# CATAWBA COUNTY BLACKBURN RESOURCE RECOVERY FACILITY TREATMENT AND PROCESSING FACILITY CONSTRUCTION DRAWINGS

**MAY 2025**  
**REV. JUNE 6, 2025**  
**REV. JULY 15, 2025**  
**REV. AUG. 5, 2025**

CONSTRUCTION DRAWINGS

6.64 SKIMMER Sediment Basin.PG

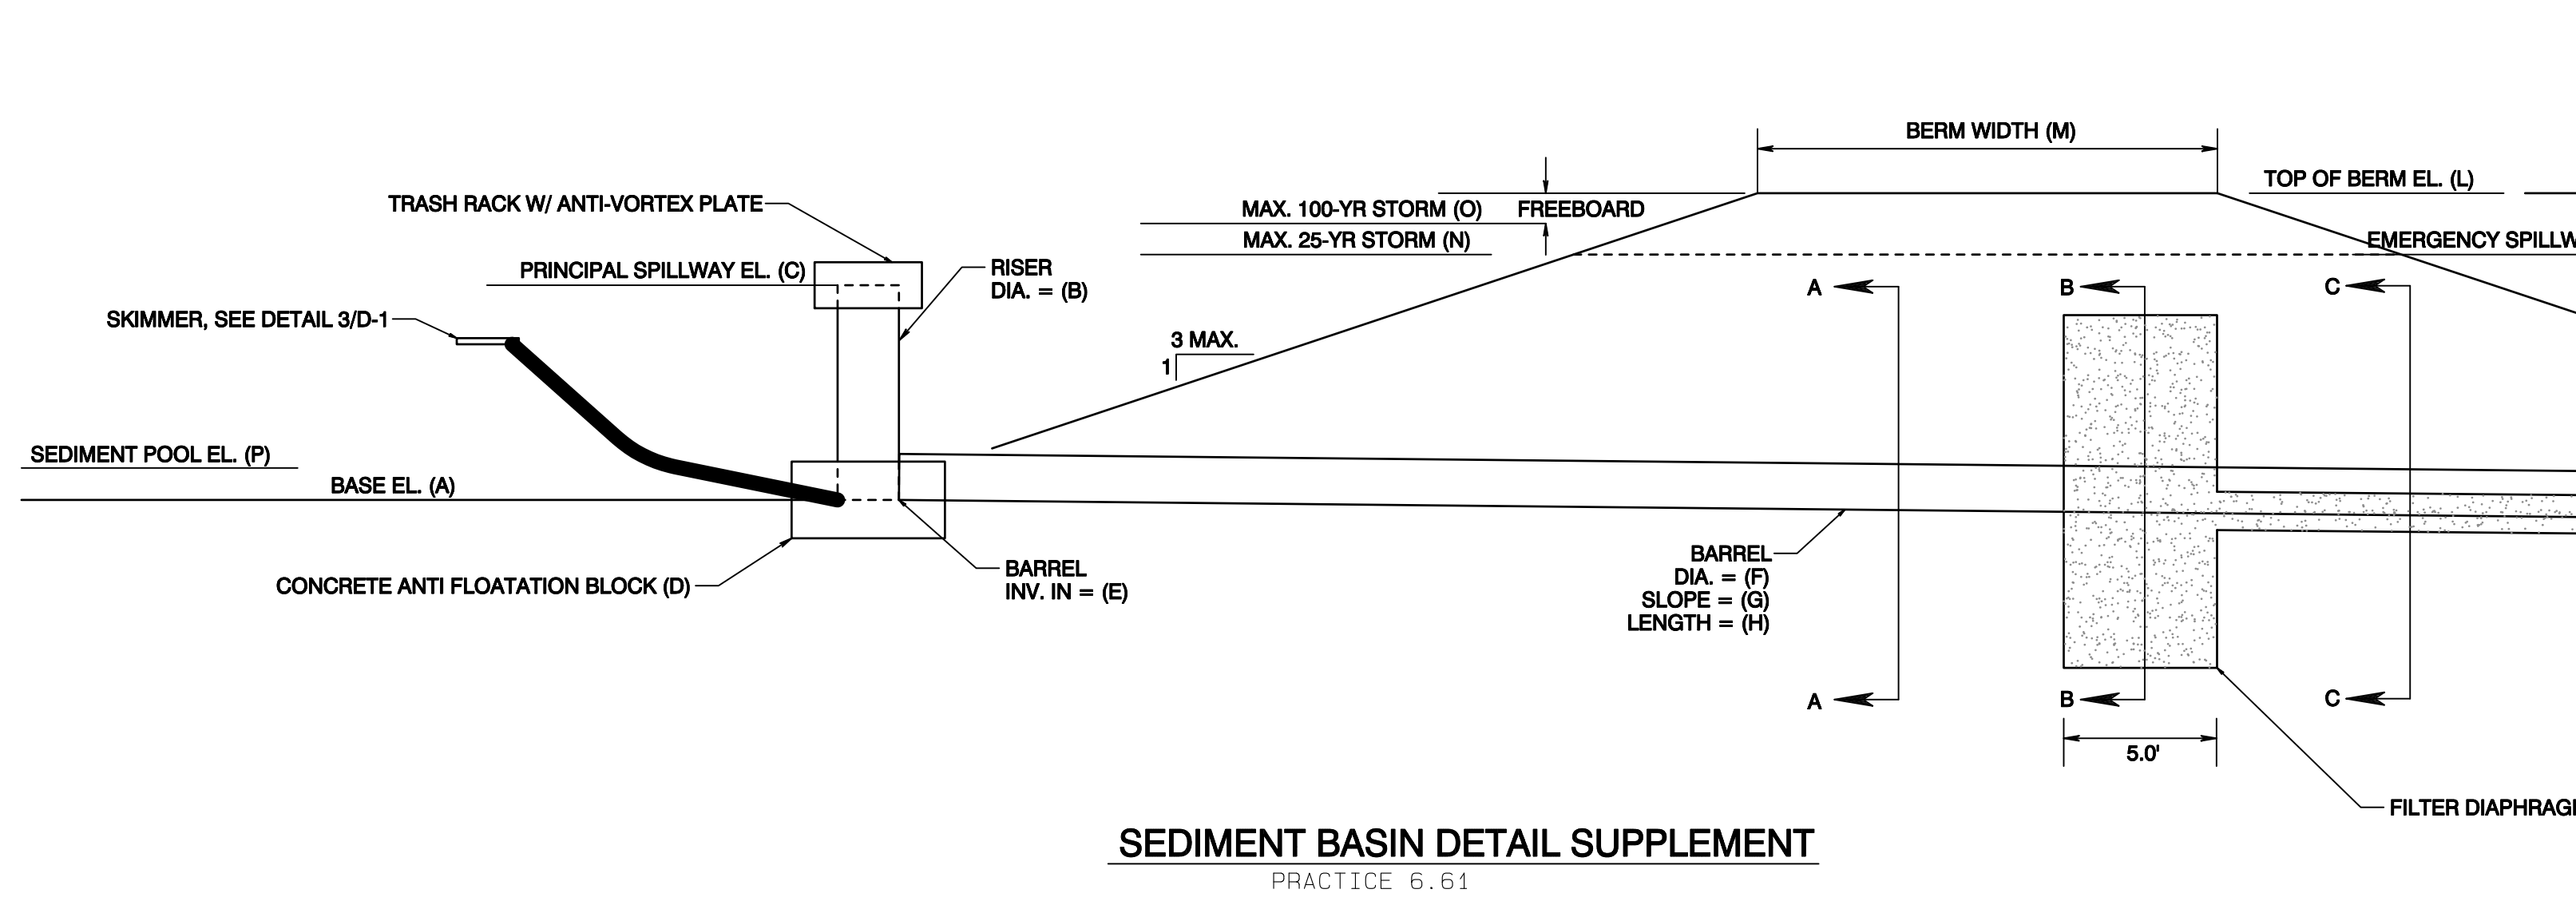
REVISED JULY 15, 2025  
1. REVISED SKIMMER SIZE ON DETAIL 1 AND DETAIL 2  
2. SEDIMENT POND 1 ELEVATION TABLE CORRECTED.  
3. SEDIMENT POND 1 RIPRAP ADDED TO EMERGENCY SPILLWAY
